SECTION 00942 – Change Order Form

No. 1DATE OF ISSUANCE: May 10, 2024EFFECTIVE DATE: May 10, 2024

OWNER: Indian River County
 CONTRACTOR: Close Construction Services
 Project: Kiwanis Hobart Park New Restroom
 OWNER'S Bid No. 2023047

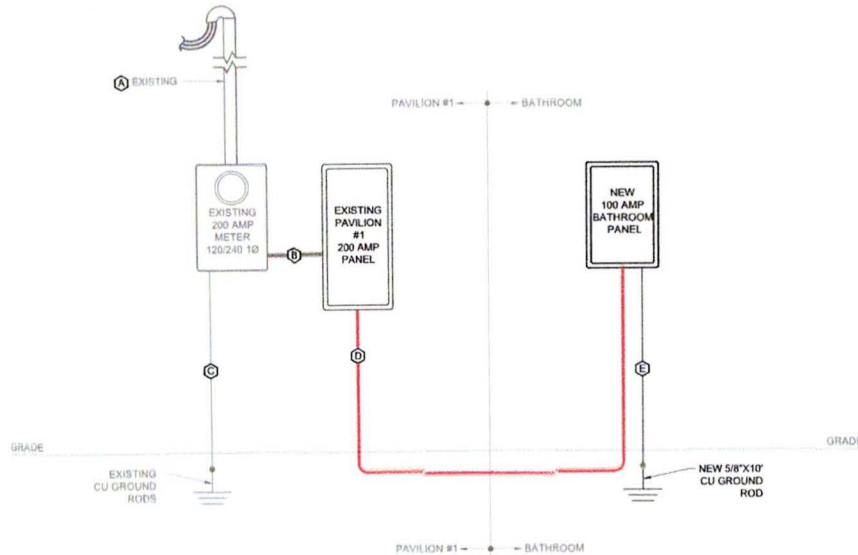
Per the “proposed riser changes” indicated on Page E-1, we are pleased to offer the following proposal to extend the electrical conduit and wire an additional 30’ to an existing panel and pull the power from the existing meter and panel, including necessary saw cutting and patching:

The building inspector has asked that the Page E-1 be amended, signed and sealed so that we may submit it to the building department to update the permit and permitted plans.

- INSTALL (1) 100 AMP SUB PANEL AT NEW BATHROOM STRUCTURE.
- FEED NEW BATHROOM PANEL UNDERGROUND FROM EXISTING 200 AMP PANEL AT PAVILION #1.
